Yamada Bulletin

Change in Fiber Optic Stroke Sensor for High Purity Series

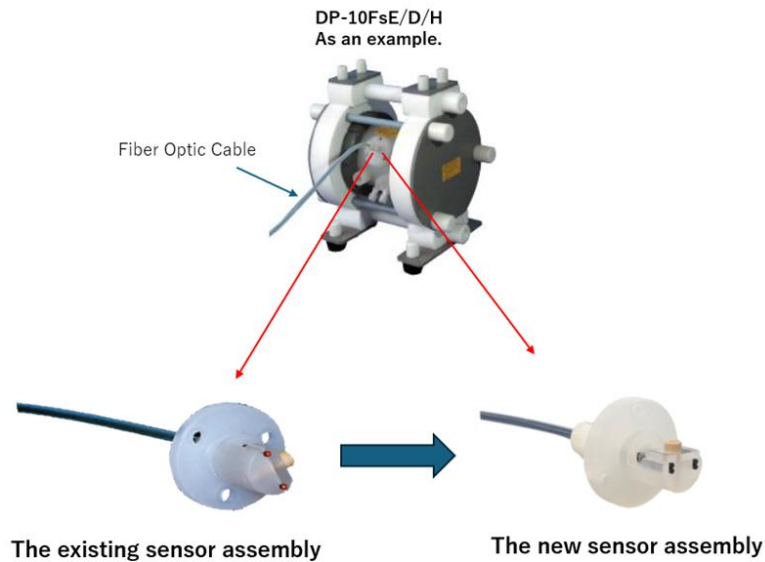
We would like to inform you that the fiber optic stroke sensors used for DP-FE/D series and DP-FsE/D/H series, which is all PTFE models with no metallic parts, will change.

More specifically, the entire unit of the sensor unit including the fiber optic cable and the connection will be changed as per pictures below.
